**APPENDIX R**

**Comments on the Draft EIS and Responses**

**CO32 League of Women Voters, A. Carson, F.H. Smith, J. Clary,  
J. Carloni, S. Fortune, page 1 of 118**

Re: OEP/DG2E/Gas Branch 3, Jordan Cove Energy Project, L.P. Docket No. CP17-495-000  
Pacific Connector Gas Pipeline, LP Docket No. CP17-494-000 FERC/EIS-0292D

Fig. 4. Temperature vs. river mile, Coos Bay, September 13 and December 19, 1973 (Arneson 1976).

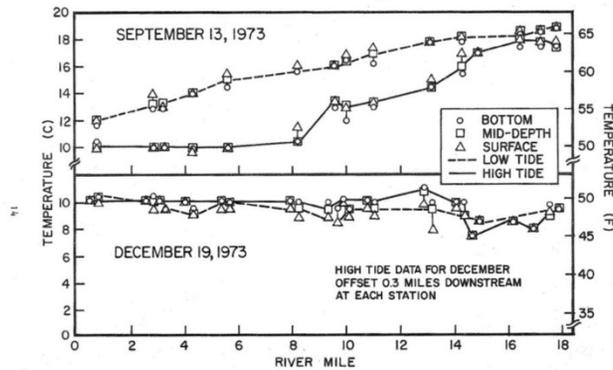
Nuisance phytoplankton growth could also be fostered with these discharges. We suggest that the alteration of landscape and changes in the flows, especially in the area of the slip, elevated temperature and dynamic nutrient and flow regimes could give rise to nuisance phytoplankton blooms. In addition, the wetland areas of the North Spit should be explored for consequences of disruption of the ground water flows and potential for developing nutrient related algal blooms. These are not investigated at all in the DEIS.

CO32-55

CO32-55 Changes in flow and temperature would not be measurable. Additionally, areas of any concentrated changes (such as directly at LNG carrier ports) would occur to very small areas that rapidly equilibrate with surrounding water. Therefore, no changes in algae blooms are expected to occur.

Fig. 5. Temperature vs. river mile, Coos Bay, March 23 and June 12, 1974 (Arneson 1976).

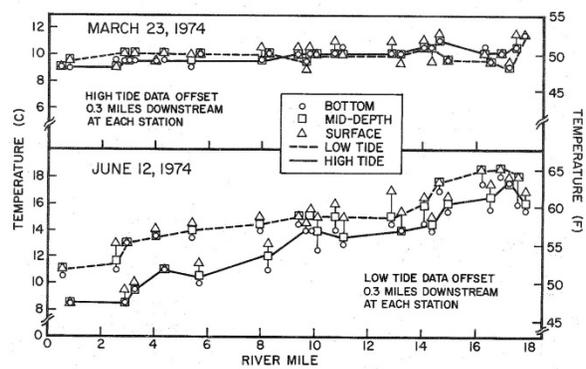
CO32-54  
cont.

CO32-54 While temperatures differed seasonally, stratification remains low in summer or winter. These differences were considered in the analysis. Additionally, models addressing sediment and turbidity from dredging were based on winter conditions as that is when dredging would occur. Summer flow scenario are not relevant to these models. Also, while river flows do vary seasonally, they are a small component compared to tidal influence. Also see our response to comment CO32-53 about COE models finding only very slight changes in dissolved oxygen from much more extensive future dredging than Project dredging.

Fig. 6. From Sutherland and O'Neill 2016 showing salinity along the cross section of the estuary from the mouth (km 0) to the Coos River (km 20).

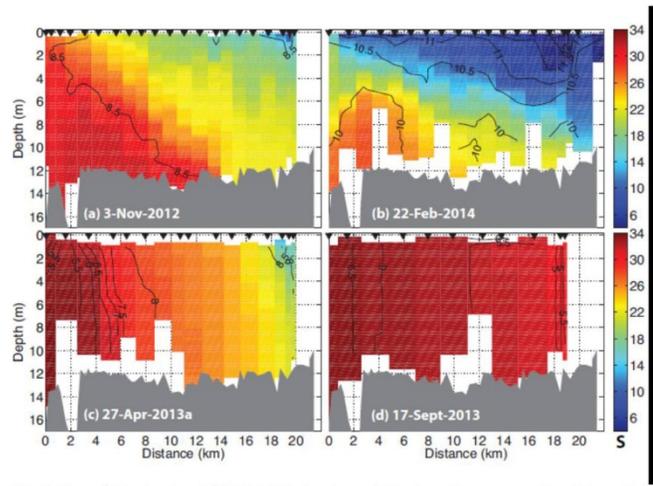
Sutherland and O'Neill (2016)<sup>125</sup> studied dissolved oxygen variability and salinity in Coos Bay and found that there were different regimes affected by river flows and oceanic conditions. They documented further the temperature profile that as summer progresses, temperatures increase as does the variability, most likely due to the interplay between warmer riverine-influenced waters and colder, upwelled waters coming from the mouth of the bay. They also showed the changes in salinity in transects that are similar to those provided by Roye (1979) but provided in meters not miles. As a result, the Roye document provides a somewhat longer profile (Fig. 6). The increased intrusion of upwelled waters can alter dissolved oxygen profiles throughout the area during summer conditions.
